**INFO-TECH CITROËN Racing C2 R2 and C2 R2 MAX N° 21/09.**

Subject : Body, rear « quick release » hobby.

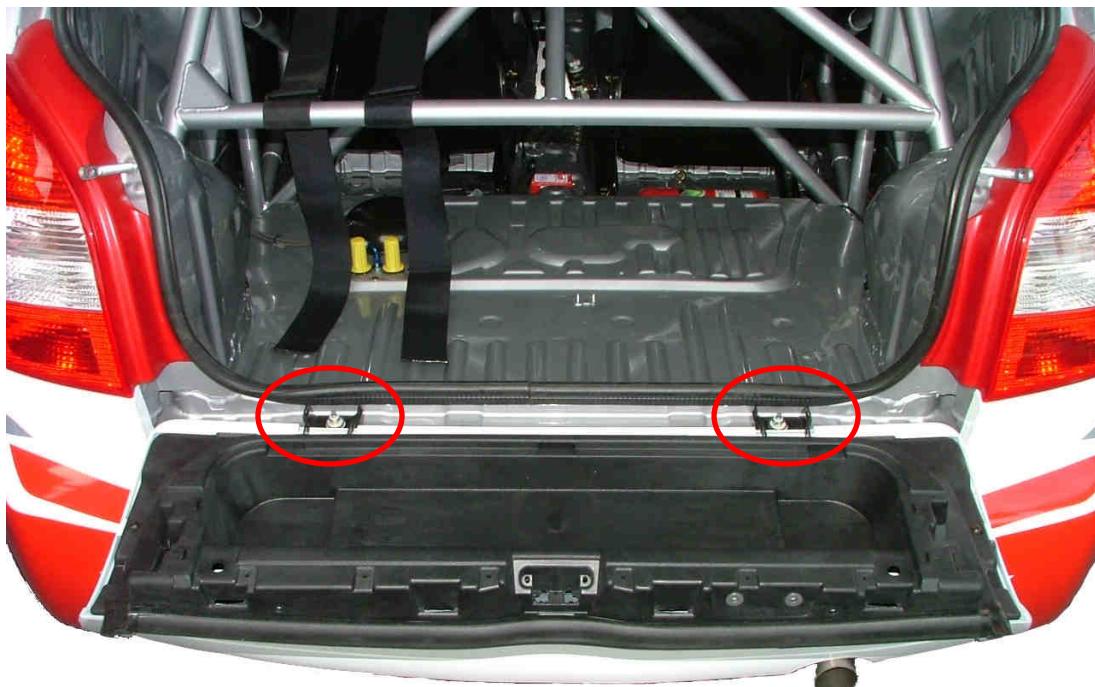
Regarding a technical request by the F.I.A., the quick release system of the rear hobby is not in accordance with the technical rules of the R group.

This way, we suggest you to remove the release side (as shown on pictures below), and to replace it by the standard system.

**I - Removing of the quick release hobby hinge (part number 2K7C62634A), hobby side :**

**II - Assembly of the standard hinge :**
